Sanitize Device Command

May ~~11~~13, 2009

Revision ~~6~~7

This new feature is intended for inclusion in ACS-2.

Figure xx – SANITIZE DEVICE State Machine

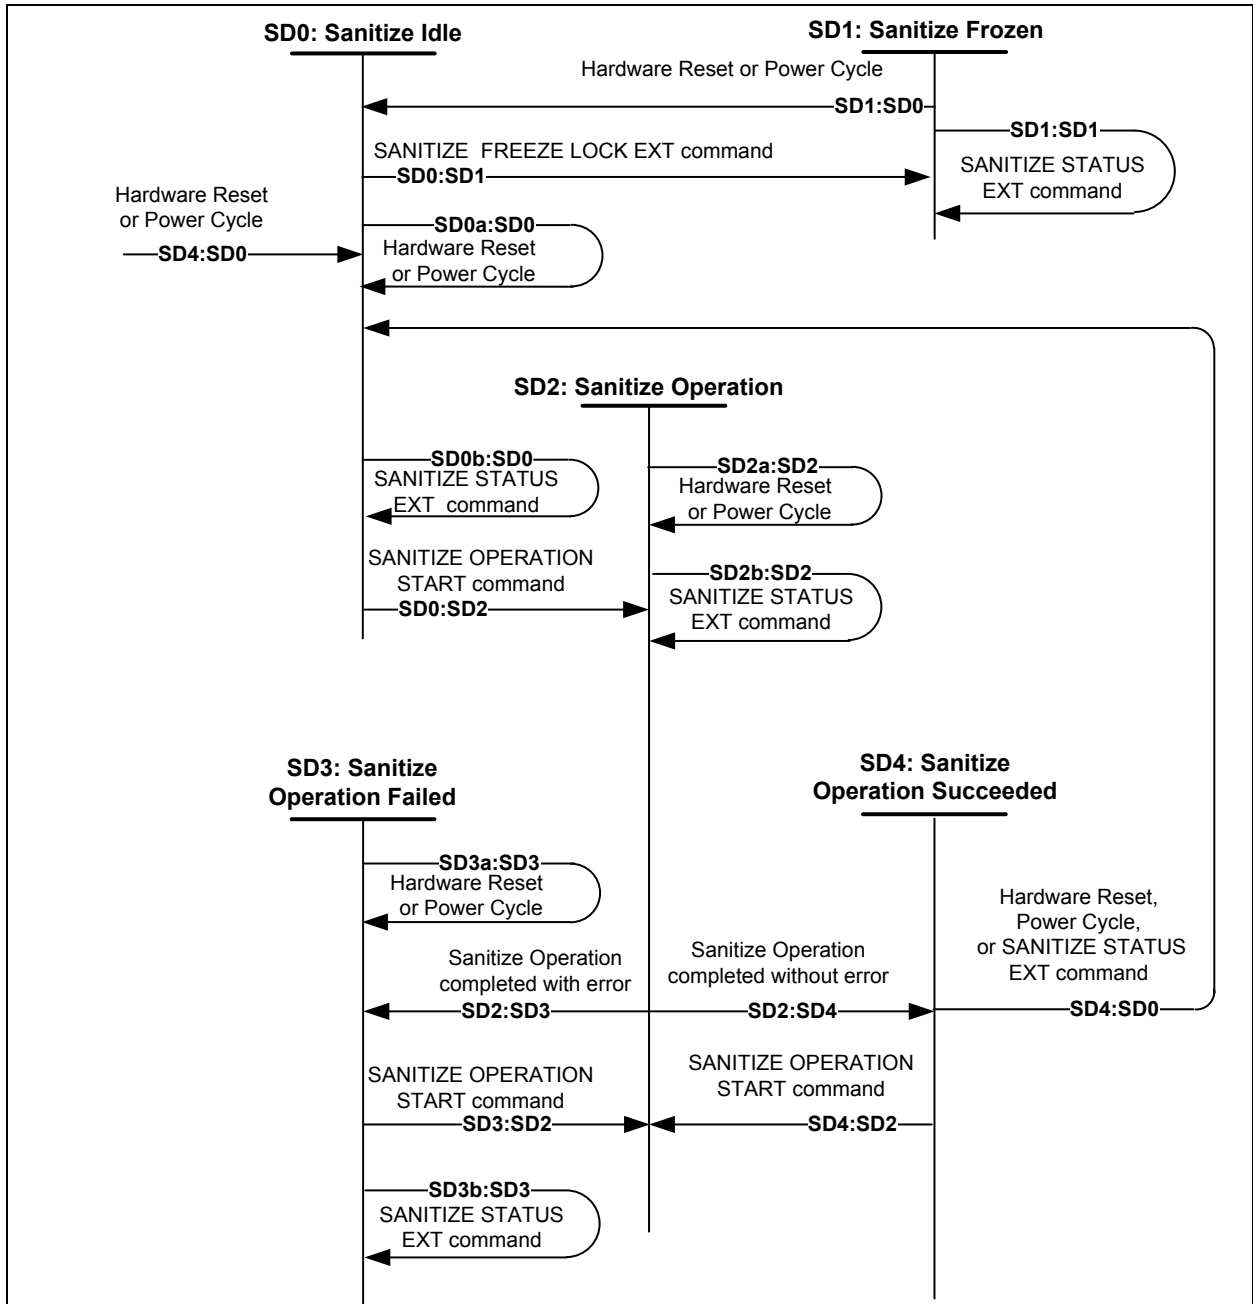
6	May 11, 2009	Extensive clarifications from Plenary (including state machine change to add additional completion states and explicitly call out hardware reset)
<u>7</u>	<u>May 13, 2009</u>	Editorial changes and State Machine label changes from May 13th Telecon

SD0: Sanitize Idle State: This state is entered when the device ~~executes a power cycle~~processes a power-on reset from SD0, SD1 or SD4.

Transition SD1:SD0: When the device is in the Sanitize Frozen state and it receives a hardware reset [or power-on reset](#), the device shall transition to the SD0 Sanitize Idle state.

- a) the device ~~processes a power-on reset executes a power cycle~~ from SD2; ~~;~~ or
- b) the device is in the SD0 Sanitize Idle state and a supported SANITIZE OPERATION START command is received.

Transition SD2a:SD2: When the device is in the Sanitize Operation state and it receives a hardware reset [or power-on reset](#), the device shall remain in the SD2 Sanitize Operation state.

- a) the device ~~processes a power-on reset executes a power cycle~~ from SD3; ~~;~~ or
- b) the device is in the SD2 Sanitize Operation state and a Sanitize Operation completes with an error.

Transition SD3a:SD3: When the device is in the Sanitize Operation state and it receives a hardware reset [or power-on reset](#), the device shall remain in the SD3 Sanitize Operation state.

- a) a hardware reset;
- a)b) [a power-on reset](#) or
- b)c) a SANITIZE STATUS EXT command
